ADDENDUM NO. 1
CITY OF DERMOTT
WATER LINE REPLACEMENT AND EXTENSIONS
10 January 2024

Replace sheets 2 – 6, 16, 22 – 25, and 37 – 38 with the attached sheets. (Revised placement of insertion valves and connection at tank).

CITY OF DERMOTT
WATER SYSTEM REPLACEMENT
GENERAL LAYOUT
REPLACEMENT OF EXISTING LINES

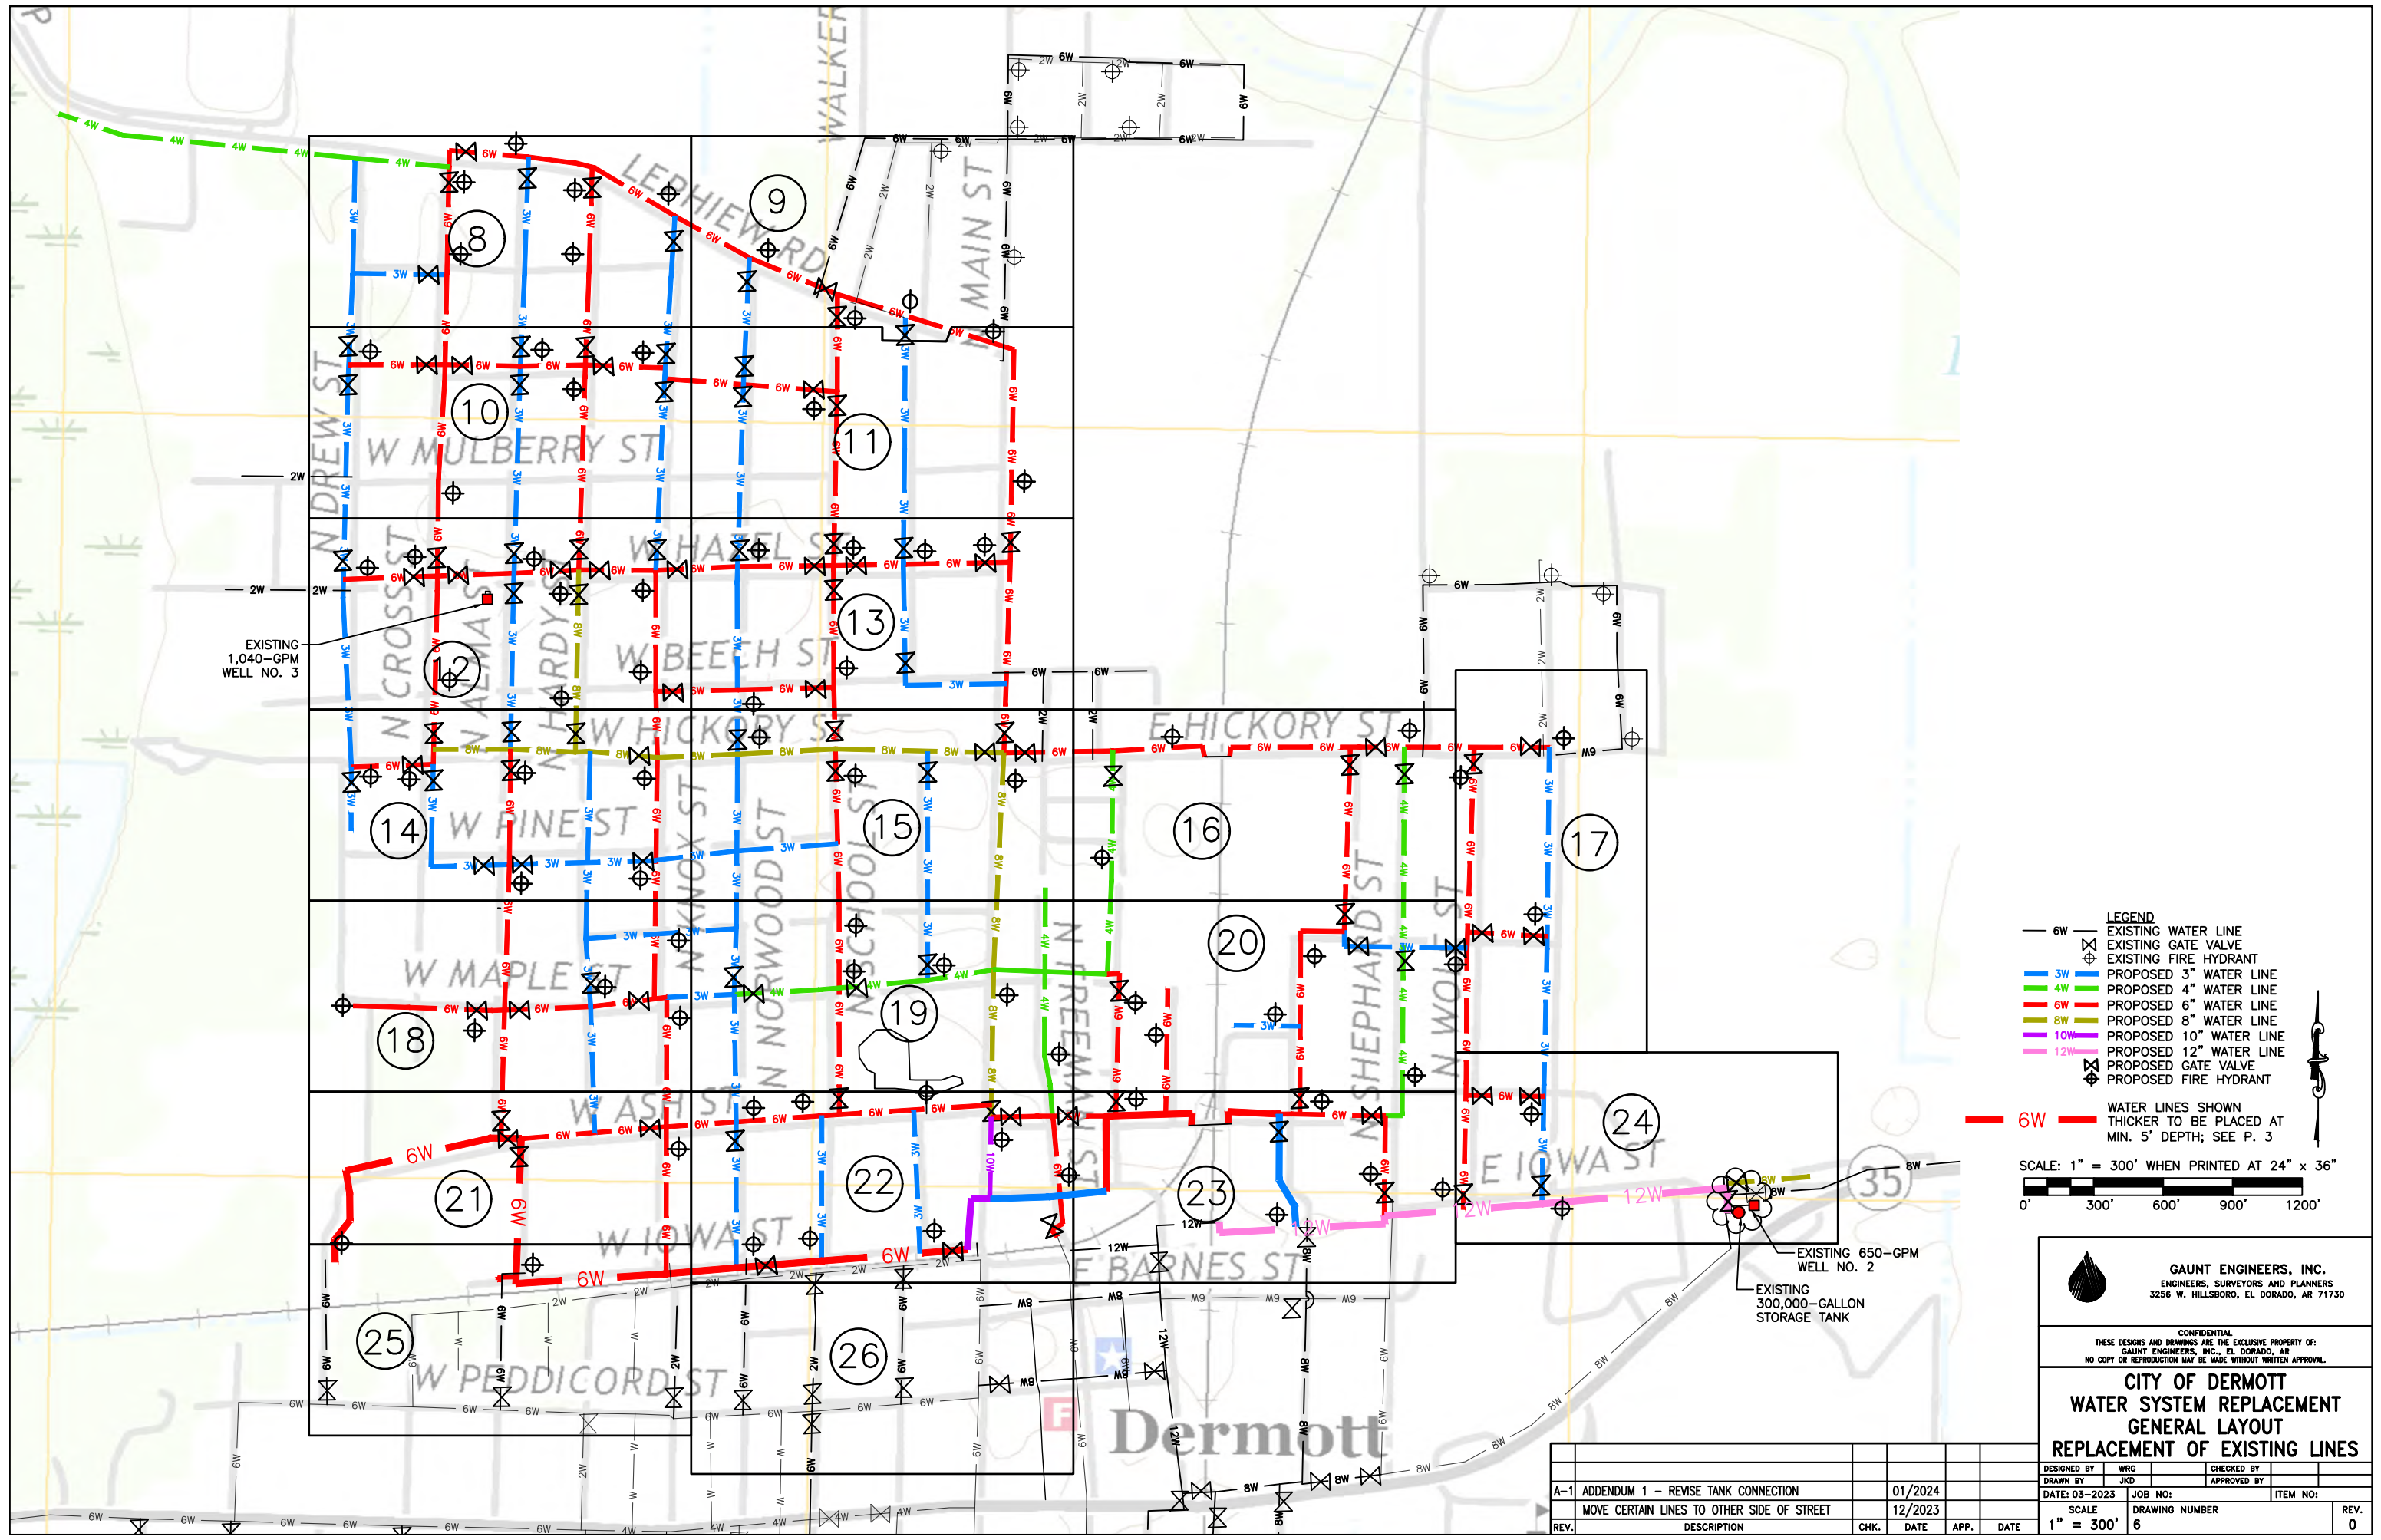
A-1	ADDENDUM 1 - REVISE TANK CONNECTION				01/2024
	MOVE CERTAIN LINES TO OTHER SIDE OF STREET				12/2023
REV.	DESCRIPTION	CHK.	DATE	APP.	DATE

**CITY OF DERMOTT
WATER SYSTEM REPLACEMENT
AND EXTENSIONS
PLANS**

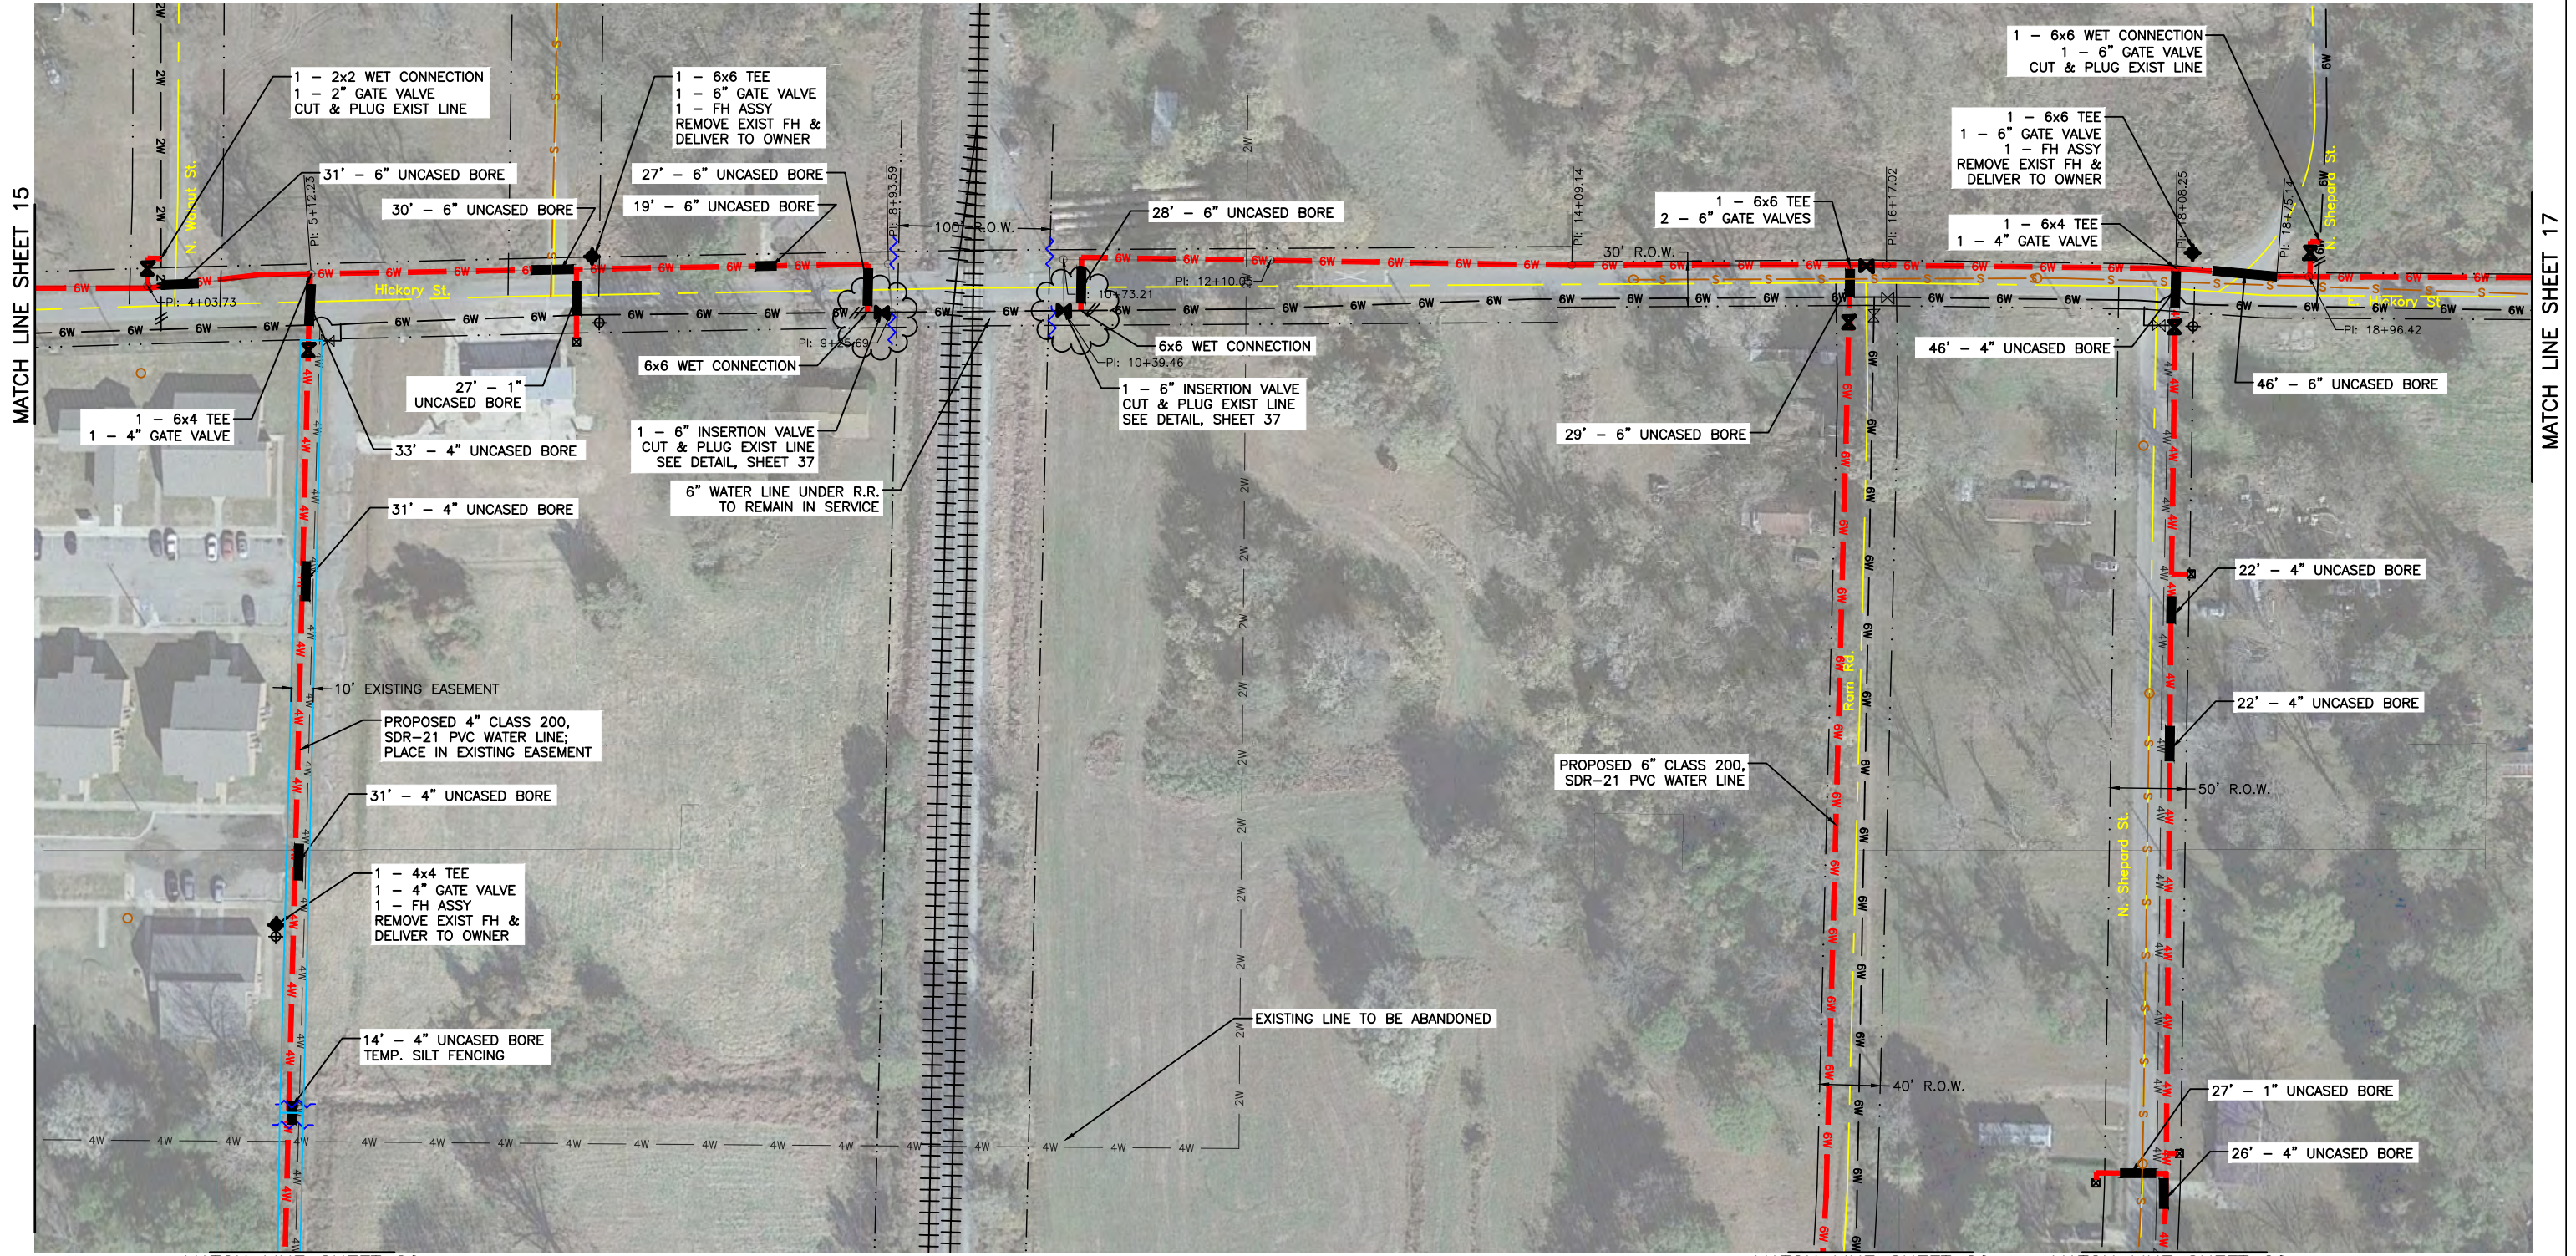
REV.	DESCRIPTION	CHK.	DATE	APP.	DATE
A-1	CORRECTED INSERTION VALVE LOCATIONS		01/2024		
	ADD STATIONING, CHANGE TAP TO WET CONNECT		10/2023

**CITY OF DERMOTT
WATER SYSTEM REPLACEMENT
AND EXTENSIONS
PLANS**

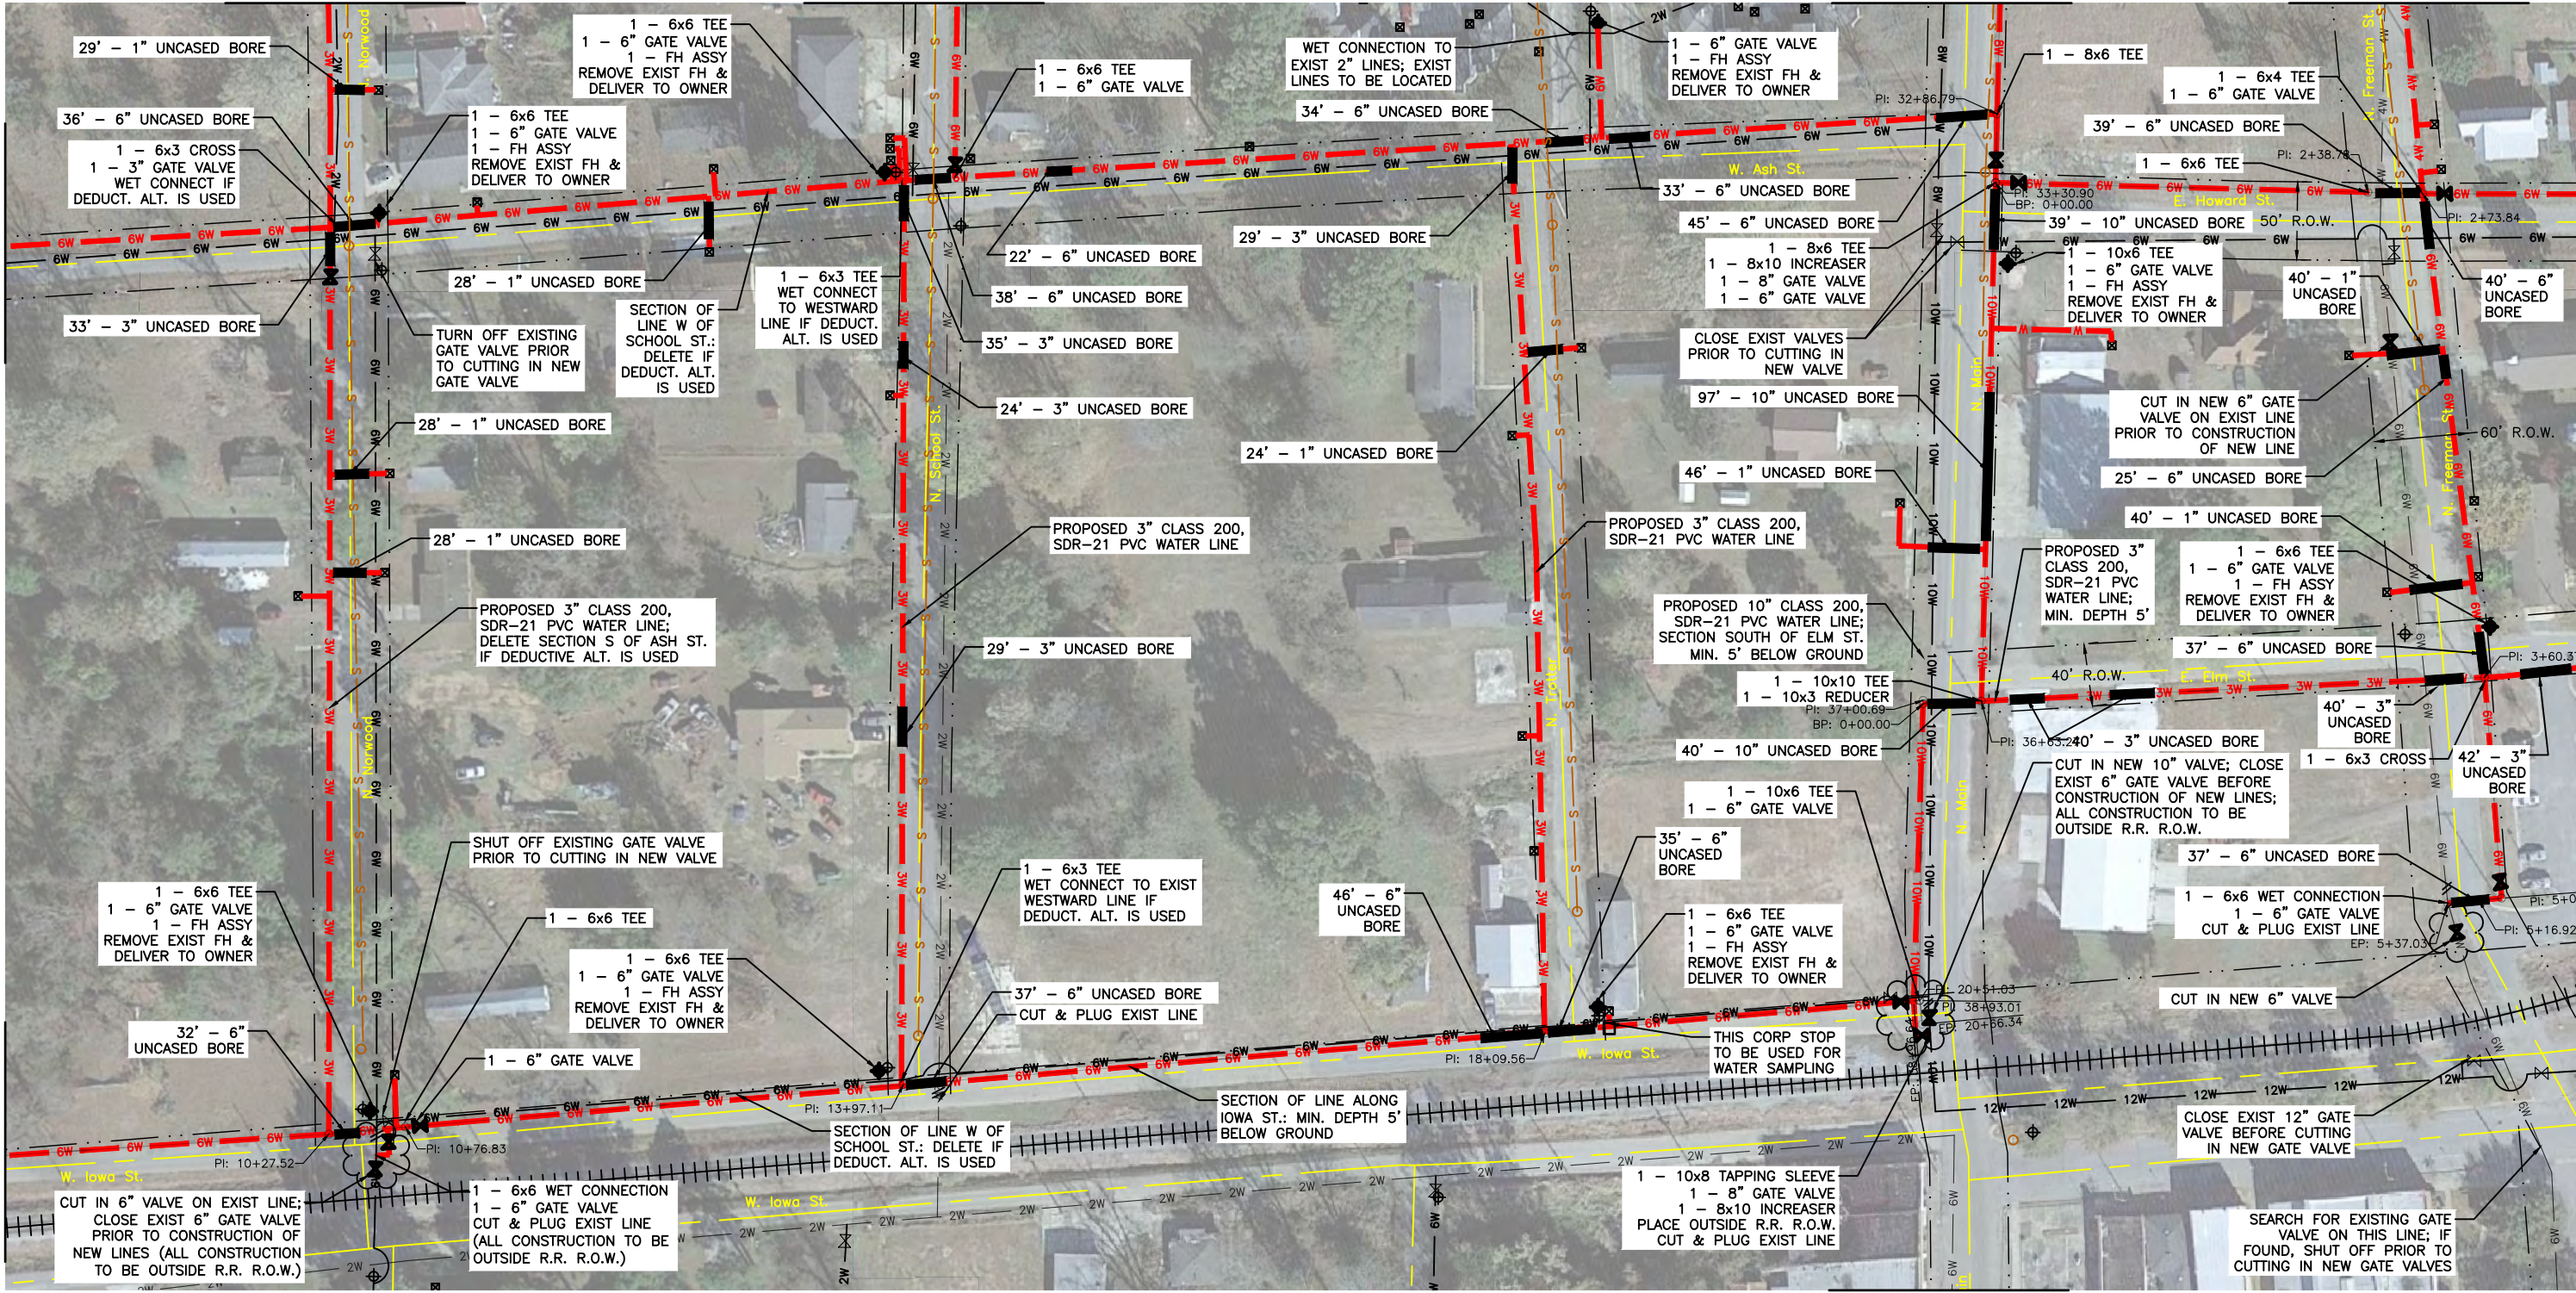
A-1	ADDENDUM - POSITION OF INSERTION VALVES	01/2024	DESIGNED BY	WRG	CHECKED BY	
	MOVE CERTAIN LINES TO OTHER SIDE OF STREET	12/2023	DRAWN BY	JKD	APPROVED BY	
	ADD STATIONING TO CERTAIN LINES	10/2023	DATE: 12-2022	JOB NO:	ITEM NO:	
REV.	DESCRIPTION	CHK.	DATE	APP.	DATE	SCALE
						1" = 50'
						DRAWING NUMBER
						22
						REV.
						0
